UNITED STATES PATENT AND TRADEMARK OFFICE

APPLICATION NO.	FILING DATE	FIRST NAMED INVENTOR	ATTORNEY DOCKET NO.	CONFIRMATION NO.
10/693,545	10/23/2003	Jung-Im Kim	3364P140	3620

Office Action Summary	Application No. 10/693,545	Applicant(s) KIM ET AL.	
	Examiner Guy J. Lamarre	Art Unit 2133

DETAILED ACTION

FIG. 2

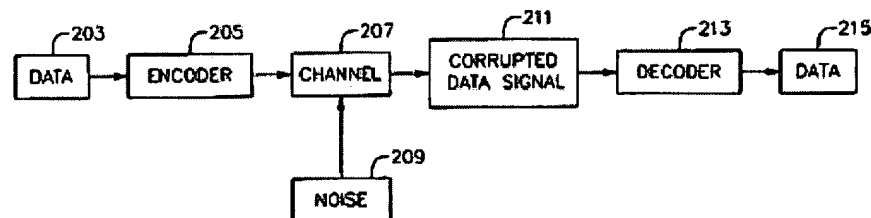
However, **Shen**, in an analogous art, discloses algorithms wherein such code substitution techniques are described. {See **Shen**, Id., Fig. 2 and col. 3 lines 19-26, 65-67, col. 4 lines 1-14 et seq.}

Therefore, it would have been obvious to a person having ordinary skill in the art at the time the invention was made to modify the procedure of the **Admitted prior art** by including therein code substitution methods as taught by **Shen**, because such modification would provide the procedure disclosed in the **Admitted prior art** with a technique whereby data processing is optimized by ‘as much as 10 dB performance improvement’ via selection of appropriate coding type. {See **Shen**, col. 1 line 30.}
